PLANNING COMMISSION AGENDA REPORT

SUBJECT: Review of the multi-family High Density Residential (R-4) component in Phase 3 of the Avila Ranch Development Plan (ADRP), consisting of a density bonus housing development which would increase the density of the R-4 project component from 125 to 145 unit , which includes 59 affordable units, and Addendum #2 to the ARDP Final EIR, and incorporating the recommendations of the Architectural Review Commission, including a fence height exception, sign exception, and a parking exception, based on findings and subject to the Conditions of Approval

FILE NUMBER: ARCH-0197-2023

Planning Commission Report – February 14, 2024

Figure 3. Earthwood Lane looking East, Market-Rate (Anacapa) Development

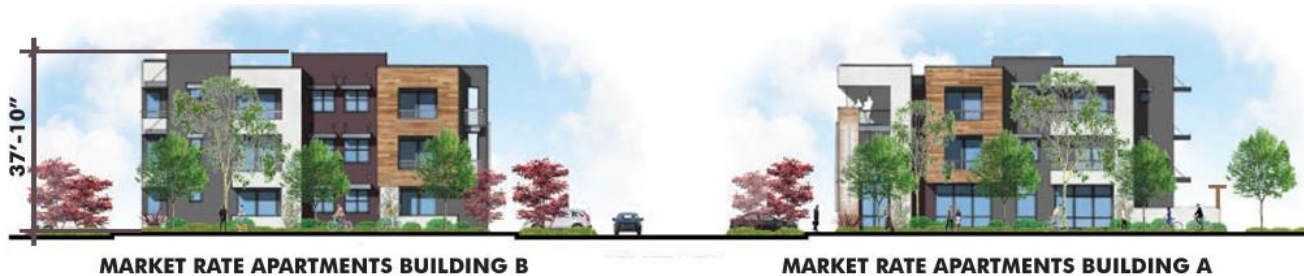
2. Slightly reduce the height of the proposed roof projections to less than 38 feet, and to make the tallest arched roof projections more rectilinear in design.

- *The applicant has provided revised elevations in response to ARC’s recommendations. The height has been reduced to below 38 feet (37 feet and 10 inches) and the roof projections have been redesigned with a rectilinear shape. See Attachment G for revised elevations.*

Figure 5. Proposed Wall/Fence Height Exception on North and West Boundaries

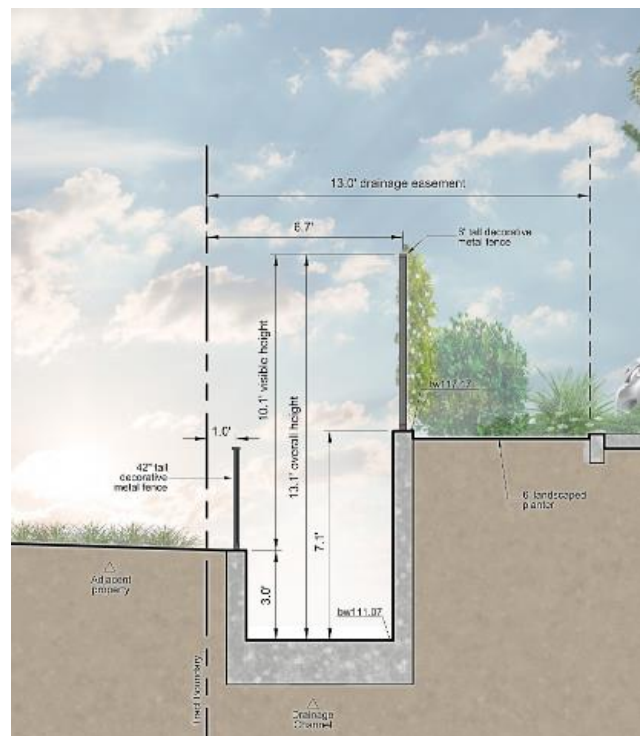
A fence height exception is requested along the R-4 north and west tract boundaries adjacent to the Manufacturing, Service Commercial, and Business Park zoned properties to the north and west to allow for a concrete drainage channel. The requested maximum total combined wall/fence height is proposed at 9.1 feet on the north property line and 13.1 feet on the west property line, which includes the depth of drainage channel below grade. The visual part of the fence and wall, when viewed standing at grade, does not exceed 10 feet. See Attachment C (Fence and Wall Height Exception Exhibits) for proposed wall heights and locations with dimensions.

This exception is requested due to the site topography and to provide for drainage between the R-4 site and the adjacent active commercial properties to the north and west. The ARDP originally envisioned a landscaped drainage swale at this location to facilitate drainage from the adjacent property (ARDP Standard 11.2), however, due to the grade change, amount of drainage, and the need for a protective safety barrier between the multi-family property and the active commercial and industrial uses, a natural swale is not feasible.

Through the stormwater management and subdivision improvement plan process through the City's Engineering Department, a landscaped drainage swale was determined to be insufficient to convey the required 100-year storm event capacity. The alternative solution is proposed to incorporate a "catch and convey" drainage channel system. The design includes screening of the channel where possible while providing access for cleaning, repair, and maintenance. The ARC reviewed and discussed the proposed fence height exception and recommends Planning Commission approve the fence and wall combination as proposed.
